Project Manager: John C. Price, (504) 862-2272, john.c.price@usace.army.mil
Subject: MVN-2012-02551-WNN

ERRATUM TO JOINT PUBLIC NOTICE

EARTHEN LEVEE AND FORCED DRAINAGE SYSTEM IN TERREBONNE PARISH

OVERALL VIEW WITH JD INFO

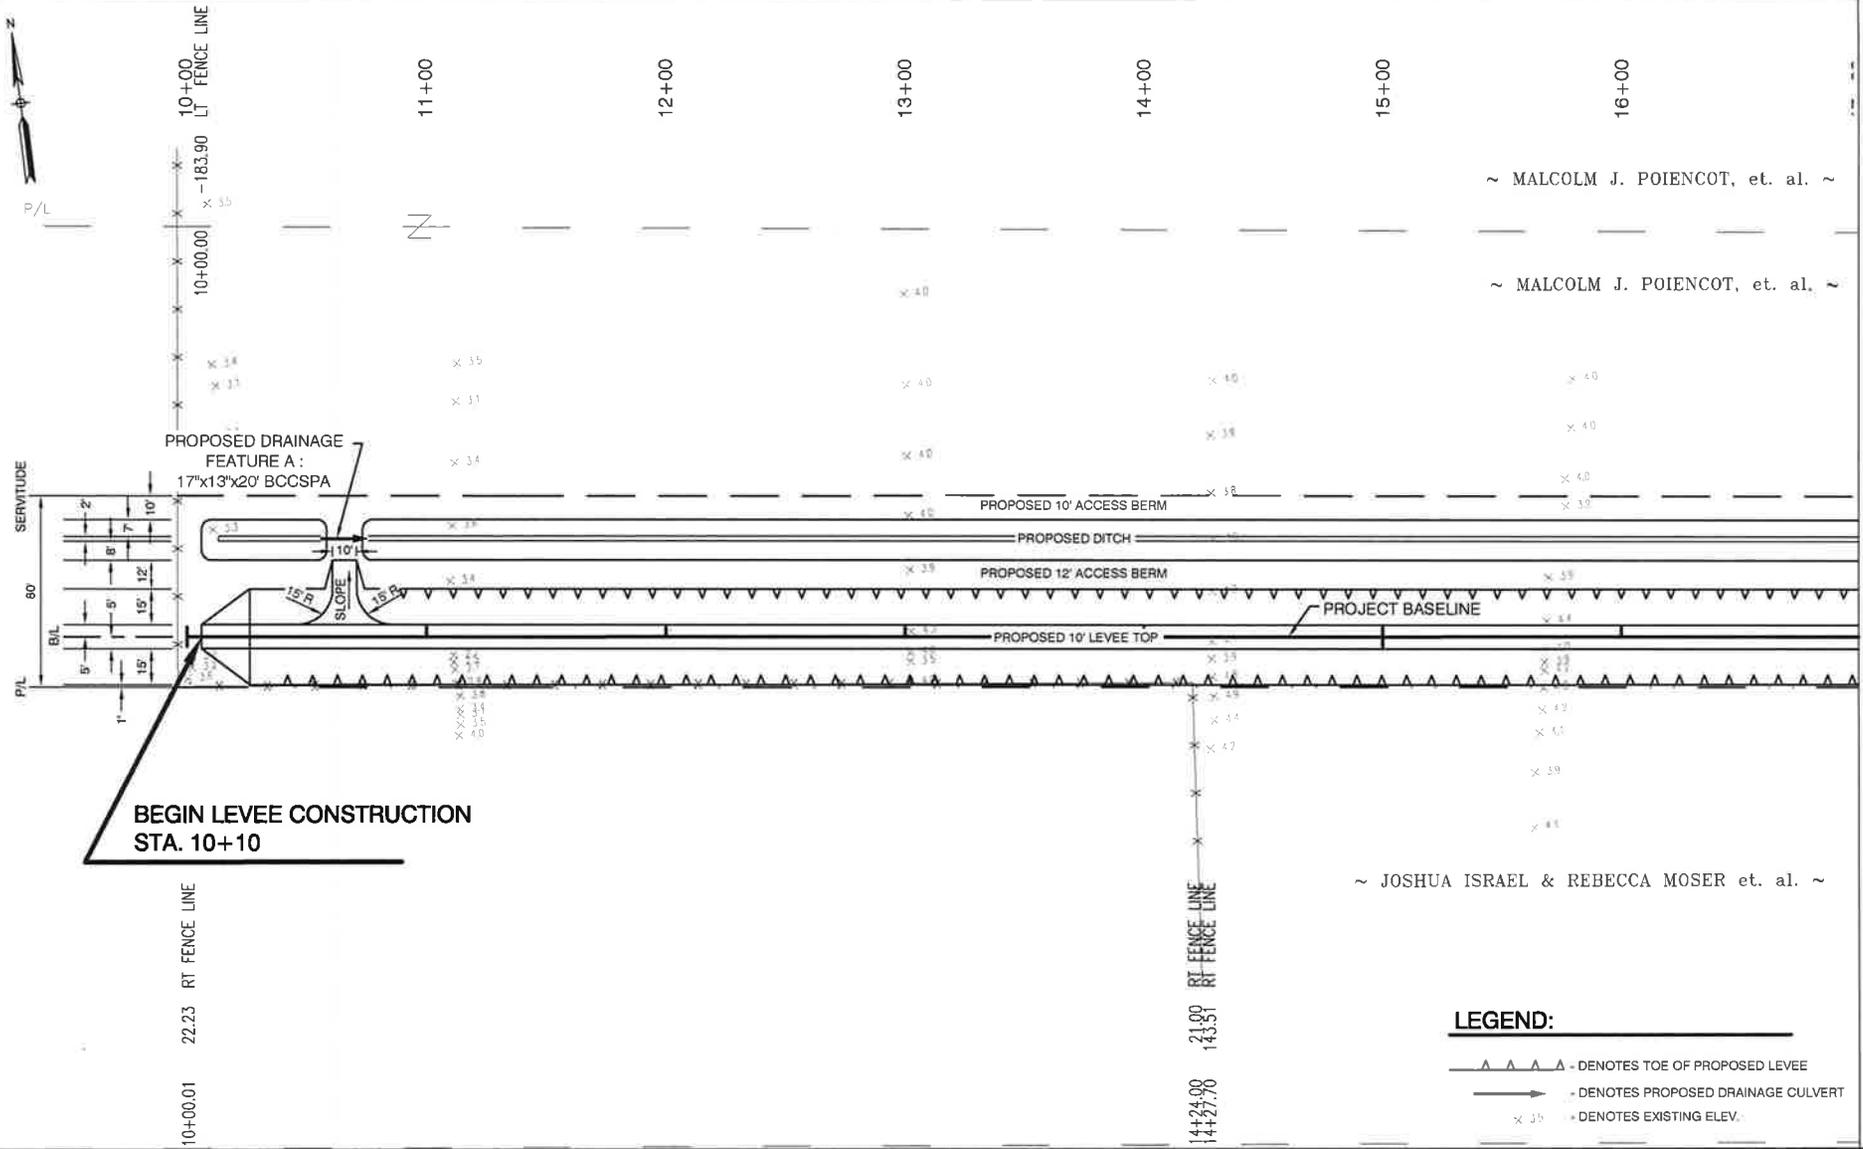
** The purpose of this erratum is to advise of the location and amount of wetlands and other waters occurring within the proposed site that may be subject to Corps' jurisdiction, which had not been determined as of the publication by OCM of the original joint public notice on December 27, 2012. The attached project drawings have been revised to identify these features and to incorporate other minor project changes.*

OTHER WATERS (0.03 ACRES)

WETLANDS (3.83 ACRES)
